Access Compliance Report

Public Rights-of-Way

(Pedestrian Signals)

Intersection ID: N/A	Main Street:	Cross Street: N/A	Location: N/A
ADA ID: D45A2EEF7692	Signal Type: One Push Button-APS	Overall Compliance: No	Severity Score: BTN 1: N/A BTN 2: N/A No BTN: N/A
Codes/Mitigation Info/Possible Solution		Field Measurements/Component Compliance

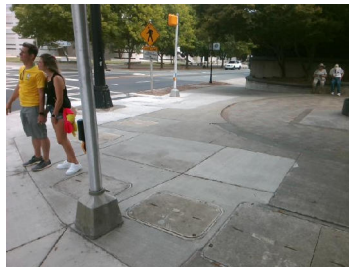
Surveyor Notes: TEXT HT 1/4, DIST BETWEEN ADDL BUTTON 388.0

PROW/ADA: R410.6, TMUTCD 4e.08, R406.2, R209.1, MUTCD 4e.10

Possible Solutions: Replace Signal Push Button With APS Button on New Post. Remove & Replace Sign.
